Project Number 001-2017
April 10, 2019

Contract Documents
Masjid Sunnah Renovation
2312 South Division Avenue
Grand Rapids, MI 49507

Addenda No. 2A

A101

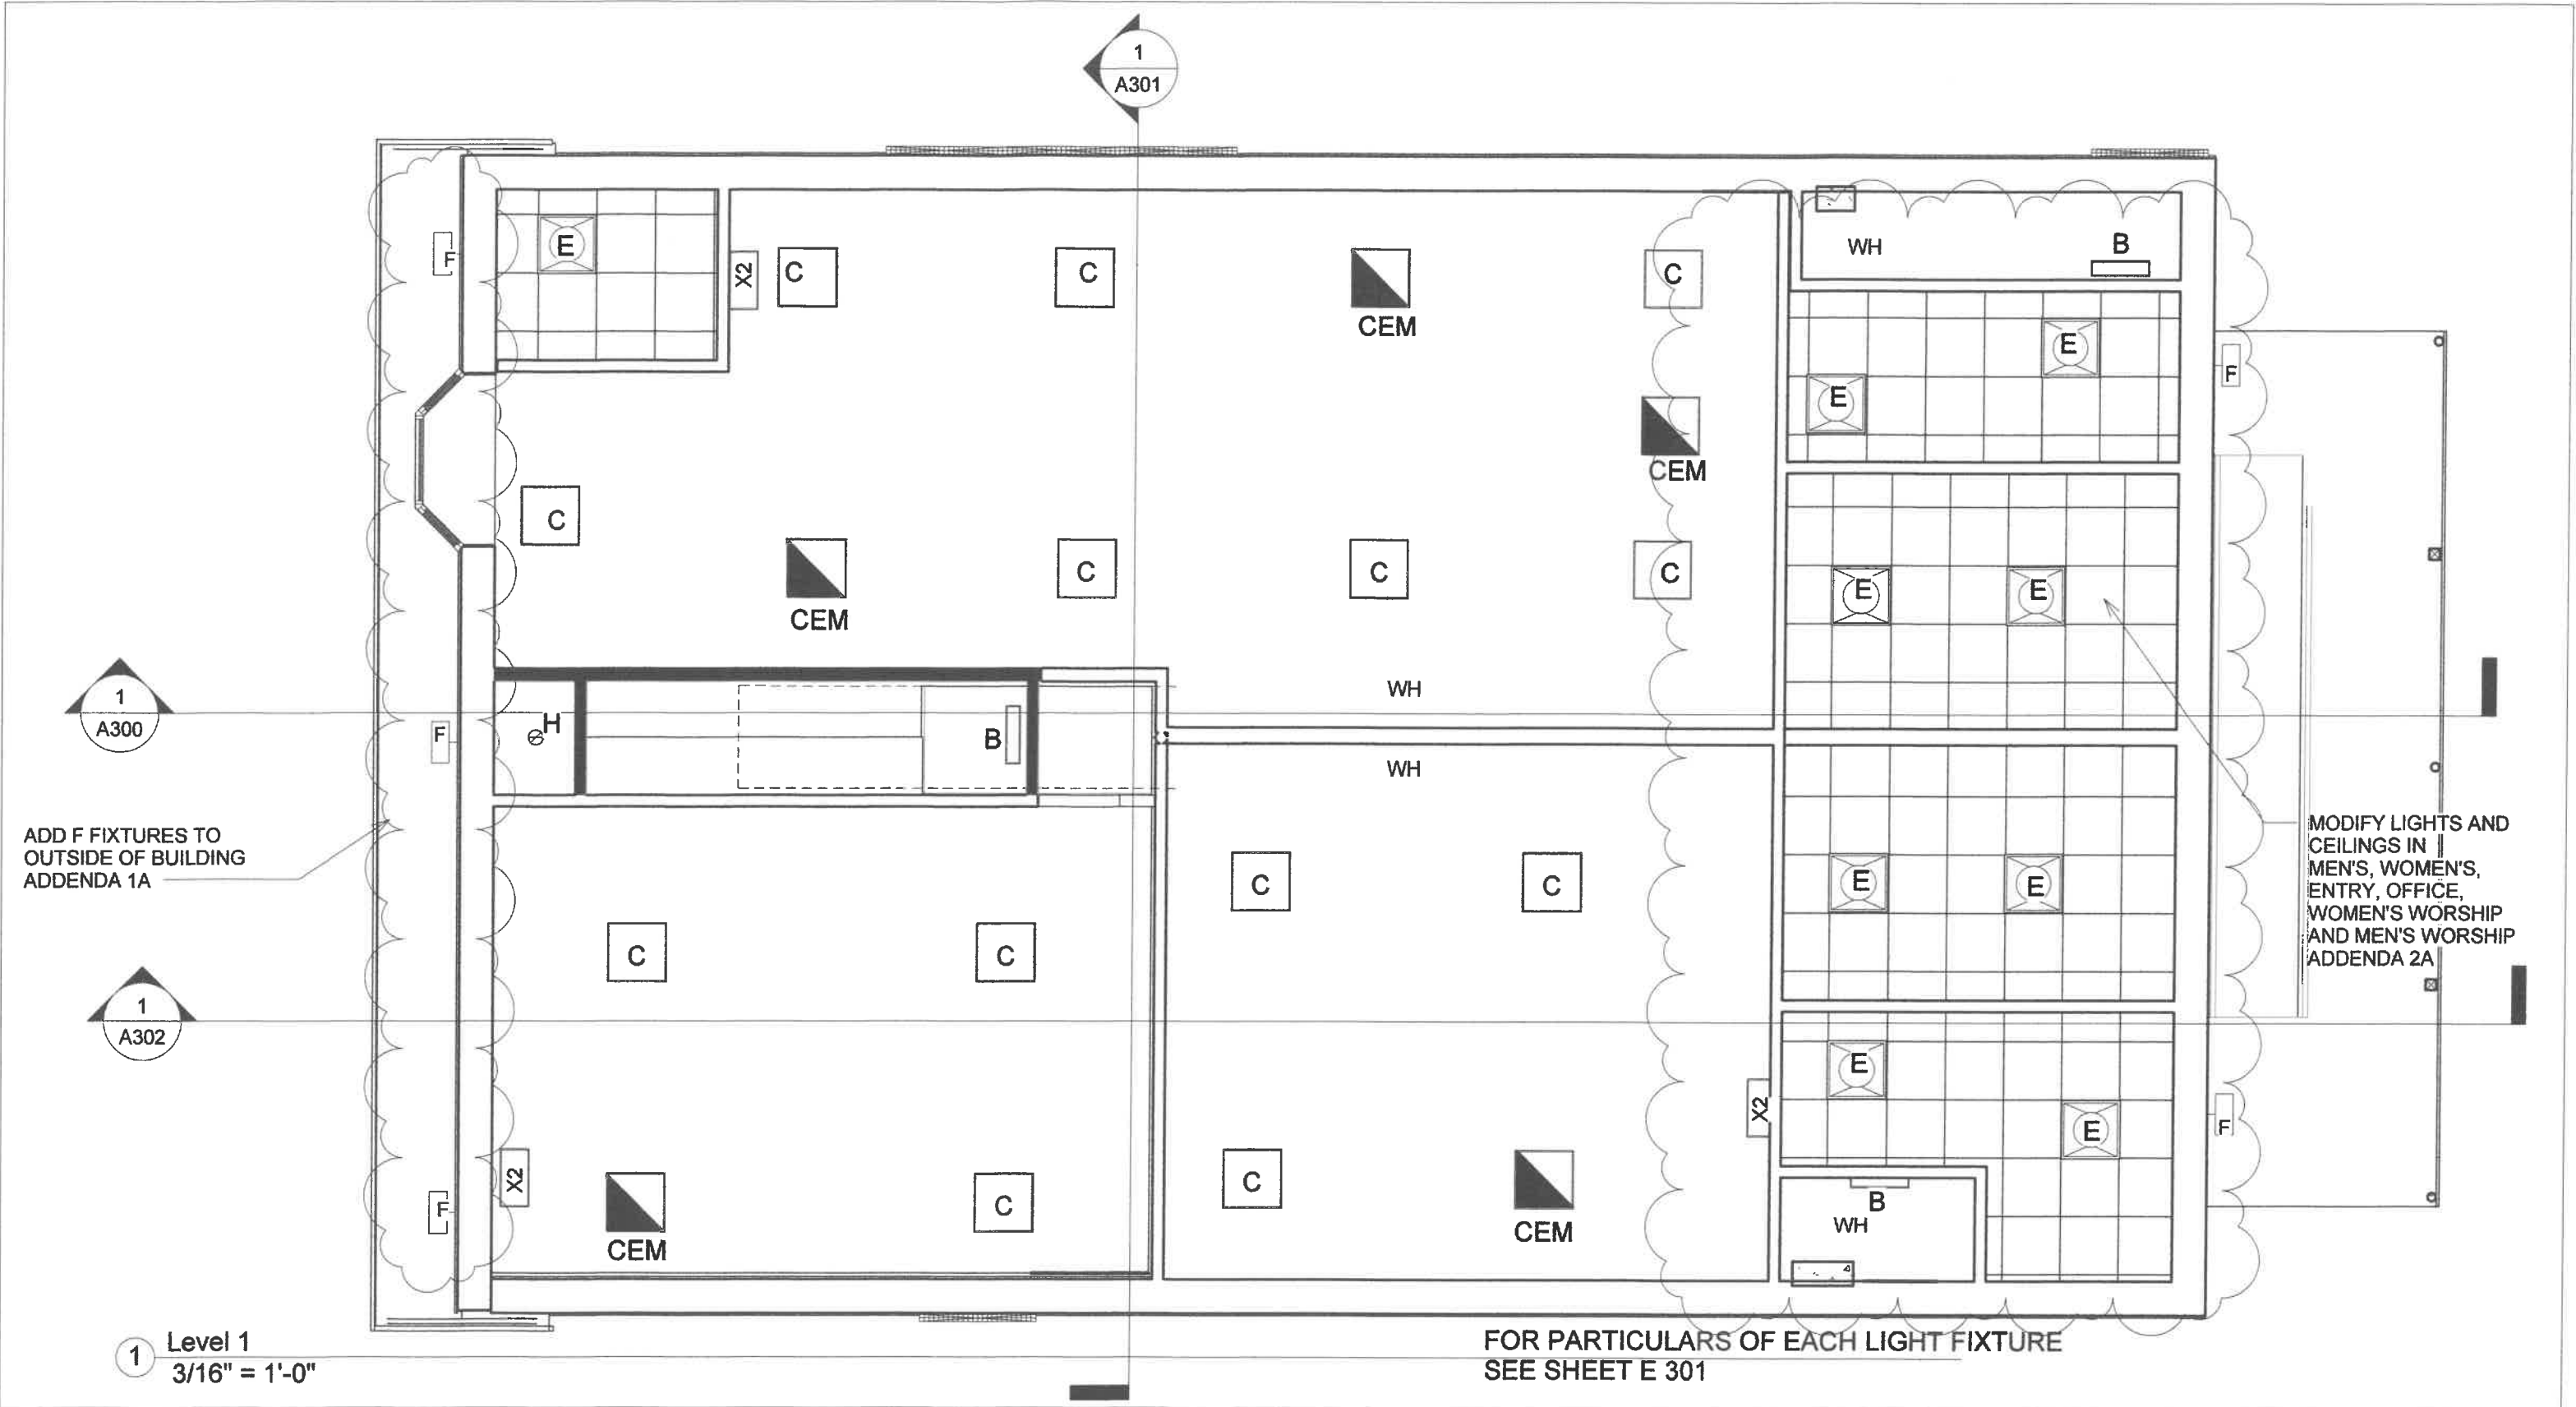
Sheets A101 and A111, See attached plans

MECHANICAL FIRST FLOOR PLAN		M201
SCALE: 3/8" = 1'-0"		
Project number	001-2017	Scale
Date	2/14/2018	
Drawn by	Author	
Checked by	Checker

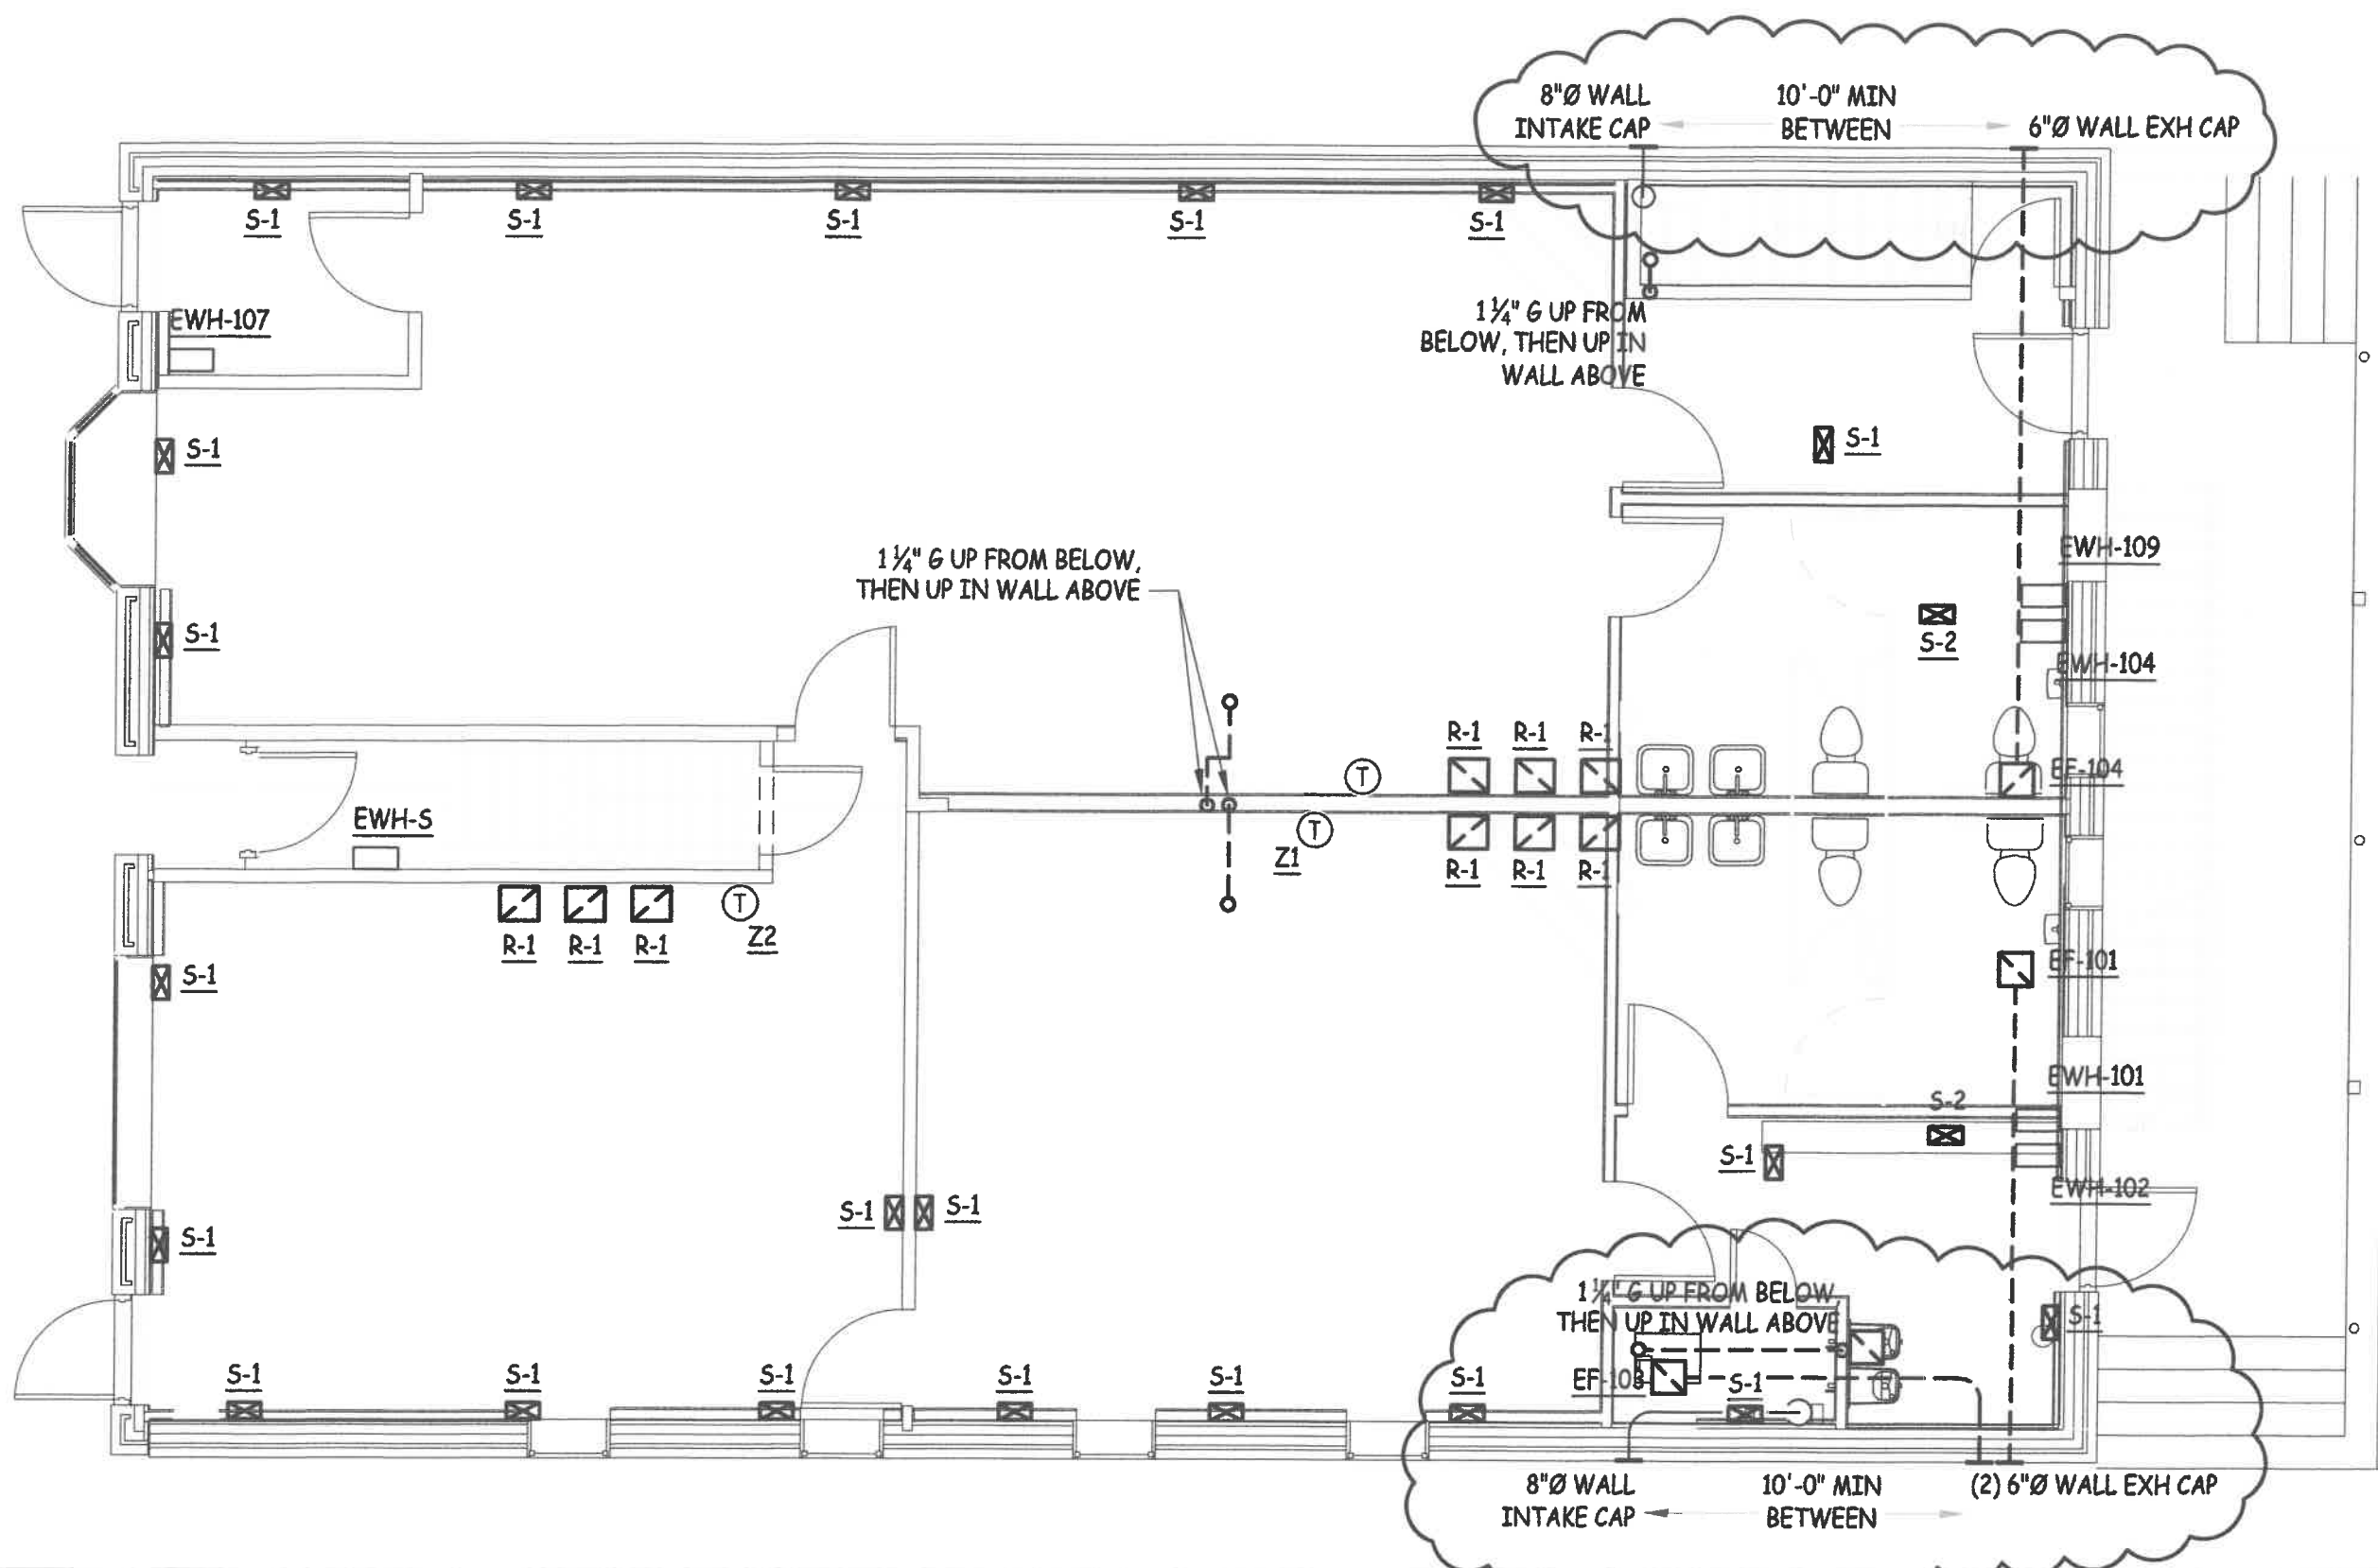
Sheet M101, M200, M201, See attached plans

No.	Description	Date
	Plumbing Permits	07-05-2018
	Mechanical and Electrical Permits	07-14-2018
	Moved Furnaces, Added Outside Air	04-10-2019
